TODD TRAIL SUBDIVISION

<u>Engineering Comments:</u> <u>FINAL PLAT COMMENTS</u> (should be addressed prior to submitting the FINAL PLAT for review and/or signature by the City Engineer):

The plat illustrates the proposed 1-lot, 12.5± acre subdivision which is located on the North side of Todd Acres Drive at the North terminus of Commerce Boulevard West within Council District 4. The applicant states that the subdivision is served by city water and sanitary sewer systems. The purpose of this application is to create one legal lot of record and two "future development" areas from three metes-and-bounds parcels.

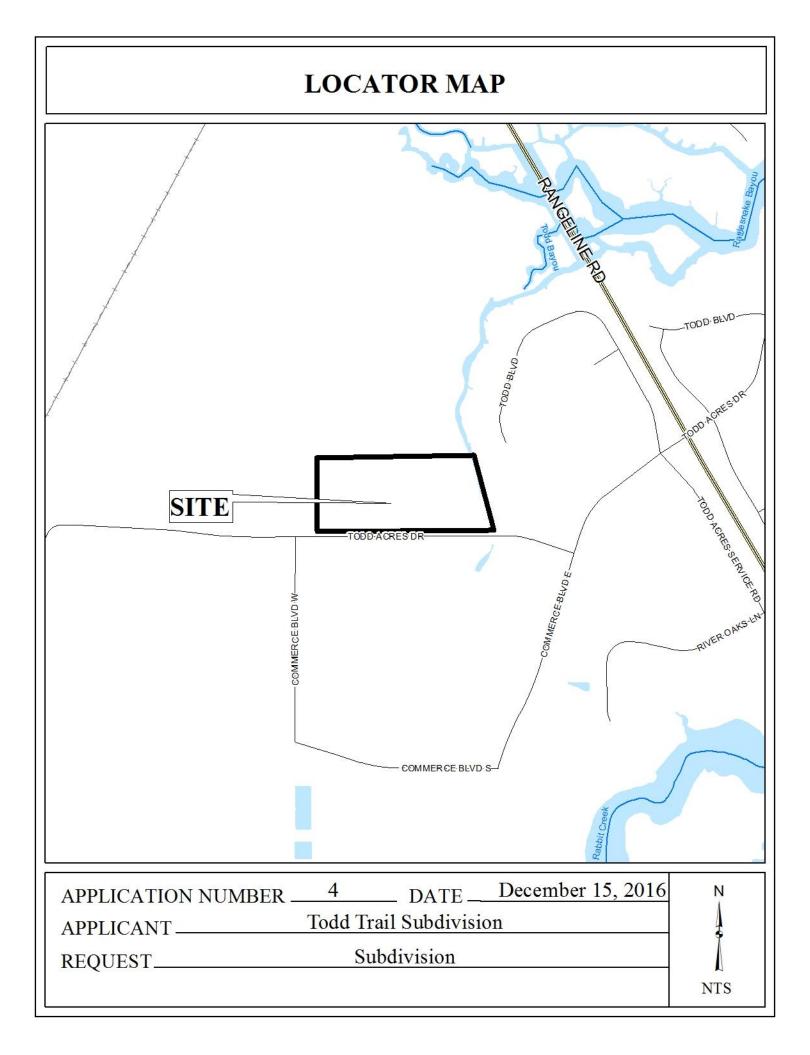
The subject lot fronts Todd Acres Drive, a minor street with curb and gutter. As a minor street with curb and gutter, this street requires a 50' wide right-of-way width. The right-of-way width is depicted as 80' on the preliminary plat and should be retained on the Final Plat, if approved. Additionally, the street is labelled as "Todd Acres Road" and should be revised to read as "Todd Acres Drive" on the Final Plat, if approved.

The 25-foot minimum building setback line is not depicted on the preliminary plat along Todd Acres Drive. If approved, the Final Plat must be revised to illustrate the 25-foot minimum building setback line on the subject site.

The proposed lot exceeds the 7,200 square foot minimum lot size requirements for lots served by public water and sanitary sewer systems. The lot size information is indicated in both square feet and in acres and should be retained on the Final Plat, if approved.

As a means of access management, a note should be placed on the Final Plat stating that the Lot is limited to two curb cuts to Todd Acres Drive, with the size, location and design to be approved by Traffic Engineering and conform to AASHTO standards.

- 1) Retention of the right-of-way width along Todd Acres Drive;
- 2) Revision of the street label to read as "Todd Acres Drive;"
- 3) Revision of the Final Plat to illustrate the 25-foot minimum building setback line along Todd Acres Drive;

- 4) Retention of the lot size information in both square feet and in acres;
- 5) Placement of a note on the Final Plat stating that the lot is limited to two curb cuts to Todd Acres Drive, with the size, location and design to be approved by Traffic Engineering and conform to AASHTO standards;

- 6) Submission of a rezoning application in conjunction with a subdivision application prior to development of the "future development" area;
- 7) Depiction and labelling of the "future development area" on the Final Plat;
